Consideration of Comments

Project 2013-03 Geomagnetic Disturbance Mitigation

Figure 1: Snapshot of Geoelectric Fields of 1989 Quebec GMD event (Source: Storm Analysis Consultants).

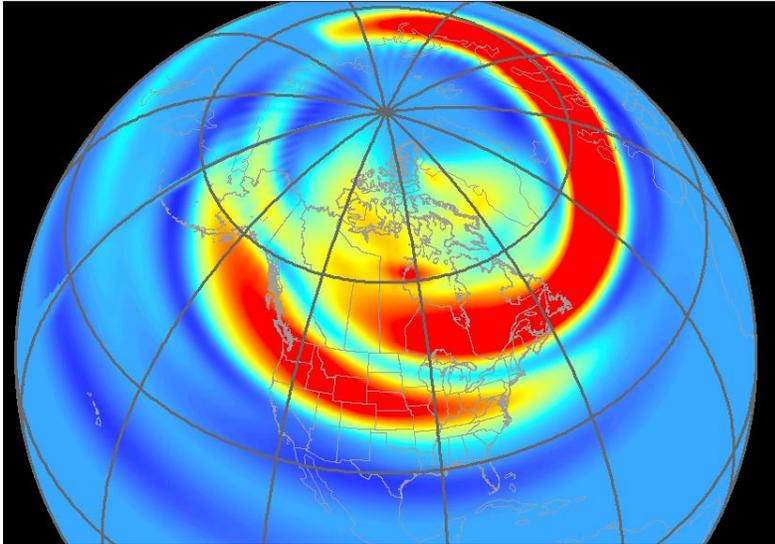
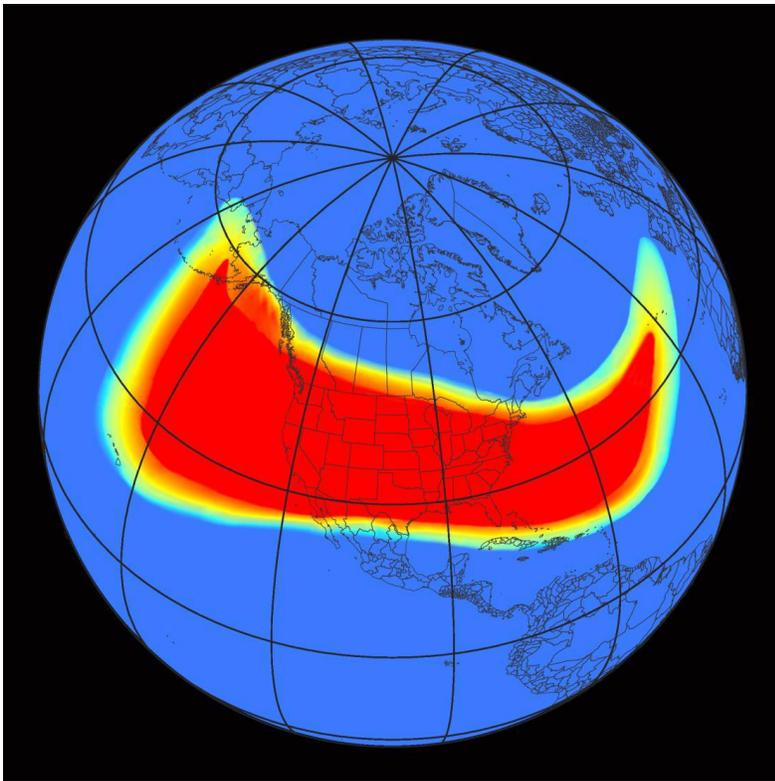
The use of the 1989 Quebec Storm as the benchmark event is of concern because simply scaling the field strengths of the 1989 Storm higher (an “intensification factor” of 2.5 is used), but leaving the same geographic footprint, does not appear to be a valid approach. While the 2.5 scaling factor is described to produce local “hot spots” of 20 V/km, in agreement with earlier findings, it fails to consider the well-known GMD phenomena that the electrojets of larger storms shift southward, as can be seen in comparing the two figures. By using the geographic footprint of the 1989 storm, the new benchmark will predict geoelectric field levels that are incorrect for geomagnetic latitudes below 60 degrees, where the center of the new benchmark storm has been set.

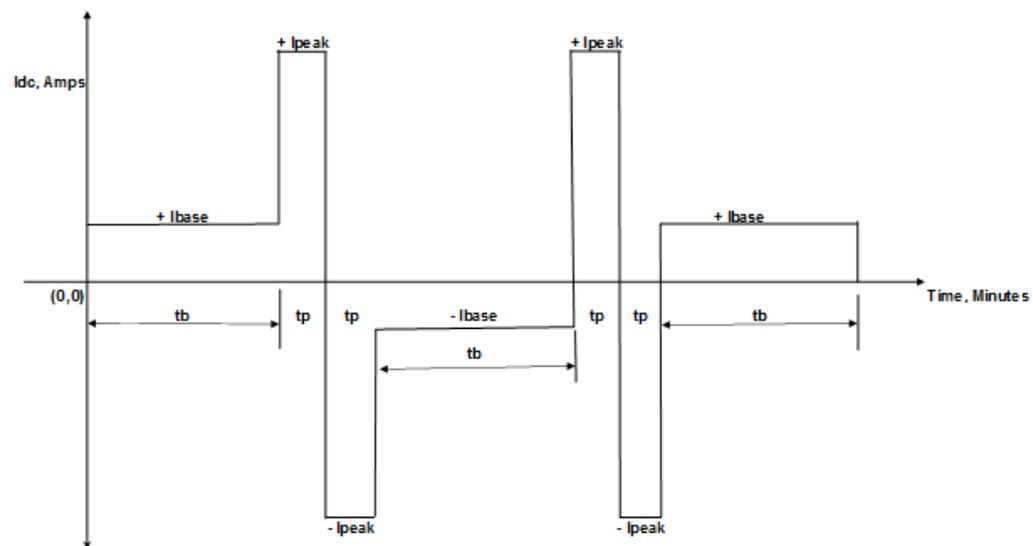
Users would not be able to predict, to any degree of accuracy, what GIC signature a transformer would be subjected to during future GMD storms. This is since the actual GIC signature will depend on the specific parameters and location of the future GMD storms. Unless a user requires thermal assessment of their fleet of transformers to actual GIC signatures, the user should be able to use a Standard GIC Signature; where the parameters of the signature (magnitudes and durations of the different parts of the signature) would be specified by the user.

This is parallel to the standard signatures used by the transformer / utility industry Standards (IEEE & IEC) for lightning surges, switching surges, etc.; where standard signatures (wave – shapes) are used for evaluating the dielectric capability of transformers.

We recommend that the NERC document suggest using the Standard GIC signature, proposed in the upcoming IEEE Std. PC57.163 GIC Guide, shown below. This signature was based on observation / study of a number of signatures of measured GIC currents on a number of power transformers located in different areas of the country. It was recognized that GIC current signatures can be generally characterized by a large number of consecutive narrow pulses of low – to – medium levels over a period of hours interrupted by high peaks of less than a minute, to several minutes, duration. Therefore, GIC signatures are made of two main stages of GIC; namely:
